# UNITED STATES PATENT AND TRADEMARK OFFICE

APPLICATION NO.	FILING DATE	FIRST NAMED INVENTOR	ATTORNEY DOCKET NO.	CONFIRMATION NO.
10/725,155	12/01/2003	Raymond V. Damadian	DAMADIAN 3.0-094	1774

## Office Action Summary

## DETAILED ACTION

*(Source: Zuk (US PG Pubs. No. 2002/0123681), pages 2 & 3)*

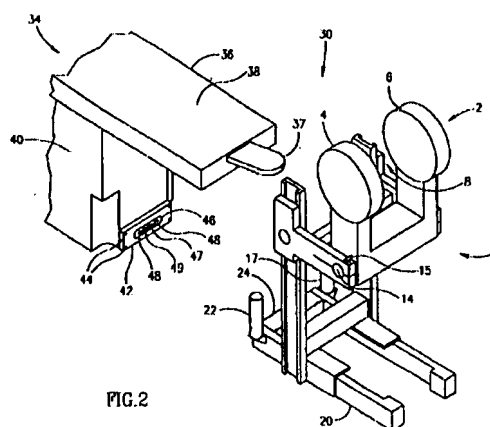
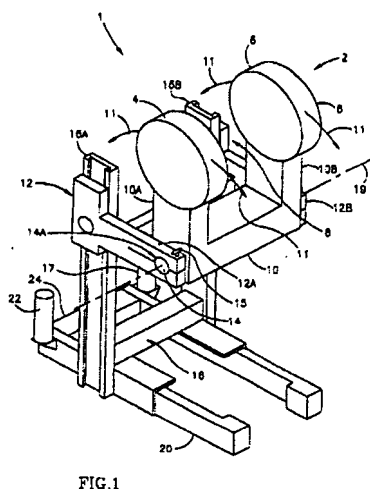
Regarding claims 1, 3-7 and 12-14, Zuk ('681) discloses a U-shaped superconducting magnet 10 having a gap for receiving a patient, and means 17 for moving the magnet so that a portion of a region of interest of the patient can be imaged, the means comprising an electrical motor which may be connected to a jack for lowering or raising the magnet (Fig. 1, ¶ 0019-21, ¶ 0065). Zuk ('681) shows a patient support platform 36 positioned within the gap for supporting the patient (Fig. 2). Zuk ('681) also provides vertical support members 16A for moving the magnet in a vertical direction (Figure 1).

Zuk ('681) further discloses that the electrical motor may be mechanically coupled to the framework, thereby comprising an electromechanical device (§ 0065).
